Technical Advisory Bulletin (TAB)

Bulletin #: TBBE1603A

Product: MELCO WIDE ANGLE CAP FRAME DRIVER OPTION

Subject: Wide Angle Cap Driver (Red) Cap Supports

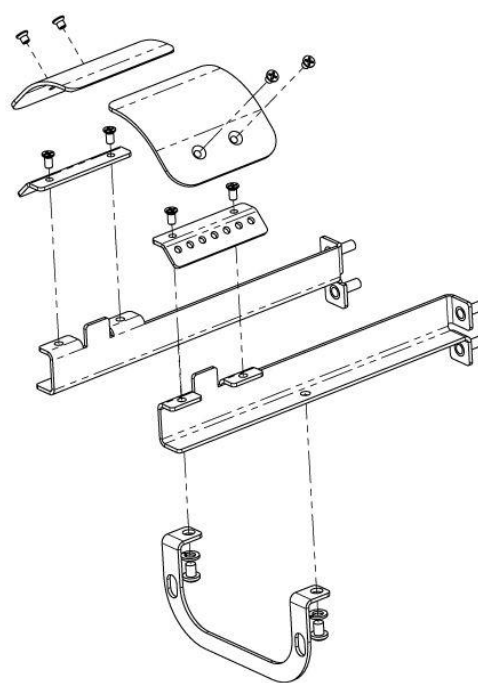
After receiving numerous feedback from customers, trainers, technicians and other Melco staff, it was decided to no longer include the Cap Support Assembly, shown below, on the Wide Angle Cap Driver Assembly. In most cases, the Cap Supports have been removed by customers based on application experience or on recommendation by Melco.

The Cap Support Assembly includes the following part numbers:

- 34173, 34172, 34171, 34170, 34168 and related fasteners.

For those customers who require the Cap Support Assembly for their application, it can still be purchased separately. The Melco part number is 34665.

Existing customers can be instructed to remove the Cap Support Assembly as required to help solve cap sew quality issues. Inform new and existing customers that the Cap Support Assembly is available to order for special applications as identified in the Parts Manual and installation instructions are in the Operators and Technical Manuals.
